Project: **Proposed 38-Lot Woods at Viewcrest Plat**
352 Viewcrest Road, Bellingham, WA

Subject: **Memorandum #2 – Response to Public Comment & COB RFI (Issued 8/14/2024)**

LOT 6 - GEOLOGICAL CRITICAL AREAS EXHIBIT

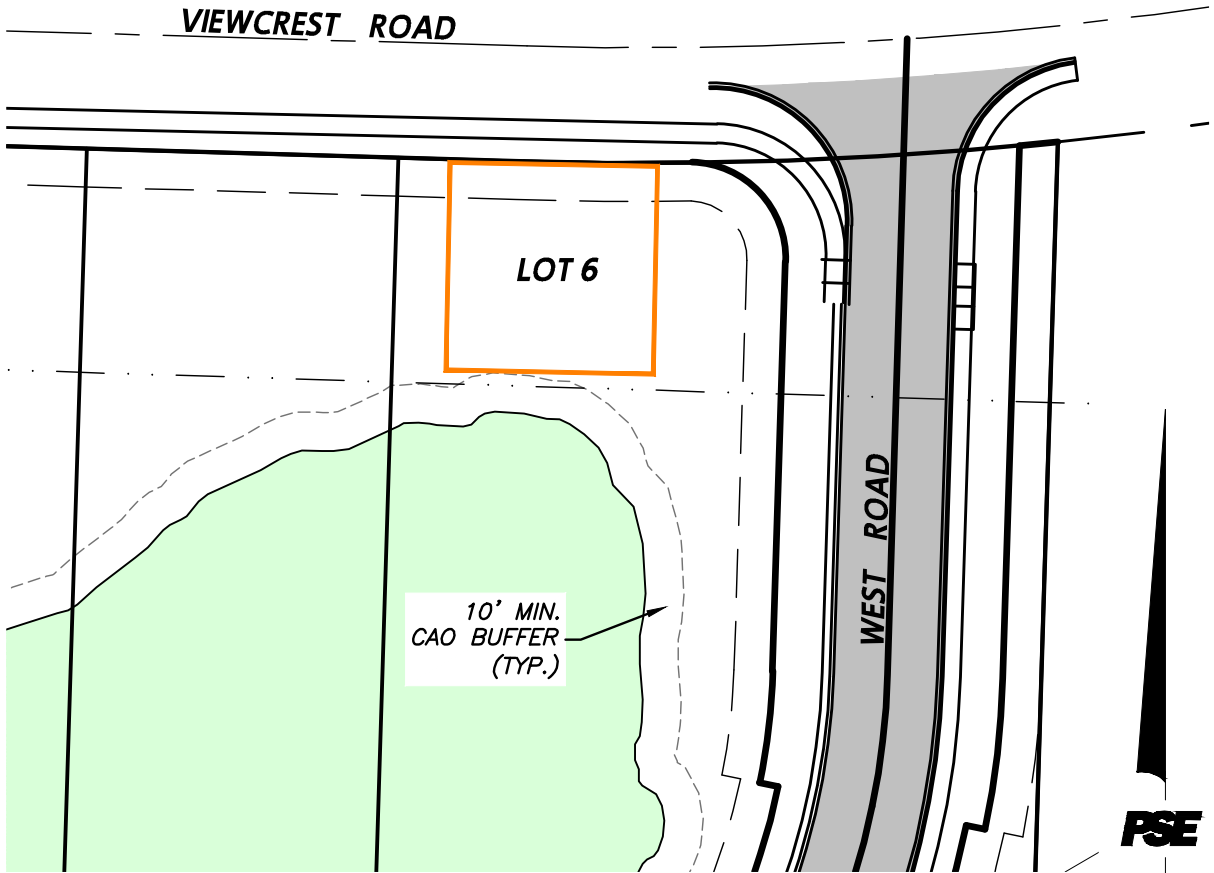
Confirm Building Envelopes Versus Geohazard Buffers:

- Lot 6 building envelope is shown to be outside of the minimum 10-foot CAO buffer (Sheet 1). The remaining northwest lots (1 to 5) are >10 feet from the delineated geohazard slope area (green).
